# TECHNICAL INFORMATION

**SUBJECT:** Control cable assembly and Cable connector on **ECHO PB-580, PB-760LN and PB-770**

**Number:** Y2016-611  
**Issued:** Nov. 30, 2016  
**Revised:** May 29, 2020

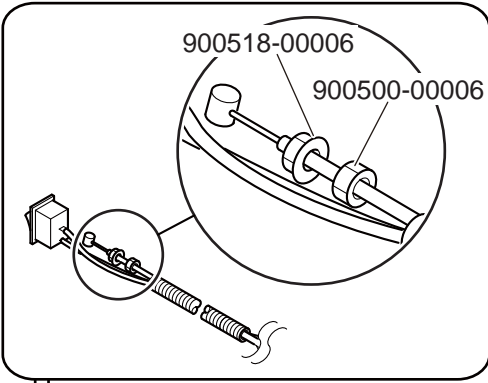
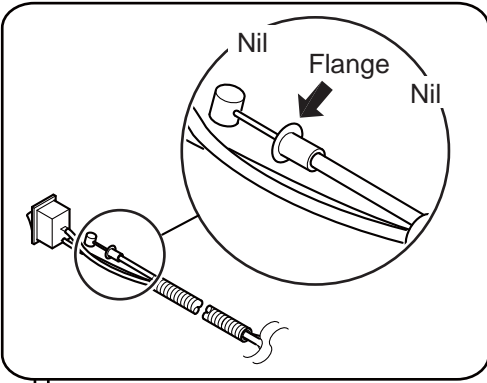
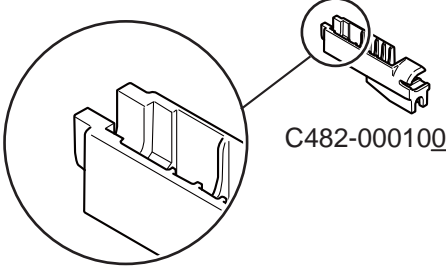
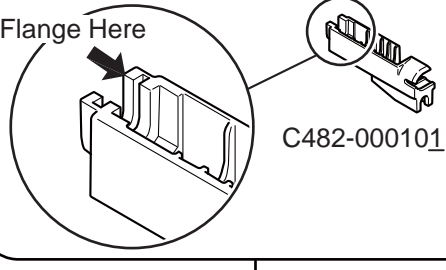
To make assembling control cable assembly in cable connector easily, control cable assembly and cable connector are changed.

Serial Number 37004003 and before	Serial Number 37004004 and after
<b>PB-580(37)</b>	Serial Number 37003226* to 37003446	Serial Number 37003447 and after
<b>PB-760LN(37)</b>	Serial Number 30001634 and before	Serial Number 30001635 and after
<b>PB-770(37)</b>	Serial Number 37041470* to 37047186	Serial Number 37047187 and after
Flange nut Nut		
Control cable assembly	PB-580: V043-001 <u>060</u>	PB-580: V043-001 <u>120</u> , V043-001 <u>180</u> , V043-001 <u>190</u> or V043-001 <u>191</u>
Control cable assembly	PB-760LN & PB-770: V043-001 <u>070</u>	PB-760LN & PB-770: V043-001 <u>110</u> , V043-001 <u>140</u> , V043-001 <u>170</u> or V043-001 <u>171</u>
Cable connector	 <p>C482-000100</p>	 <p>C482-000101</p>
Control cable KIT	Nil Nil	PB-580: P200-000510 PB-760LN & PB-770: P200-001160
<p>Control cable assembly for PB-580, V043-001<u>060</u> can be replaced with control cable KIT P200-000510. The control cable KIT includes new control cable assembly V043-001<u>120</u> and new cable connector C482-00010<u>1</u>.</p> <p>Control cable assembly for PB-760LN and PB-770, V043-001<u>070</u> can be replaced with control cable KIT P200-001160. The control cable KIT includes new control cable assembly V043-001<u>171</u> and new cable connector C482-00010<u>1</u>.</p> <p>Cable connector C482-000100 can be replaced with C482-00010<u>1</u>. The new cable connector C482-00010<u>1</u> has been already installed on some units before these serial numbers.</p>
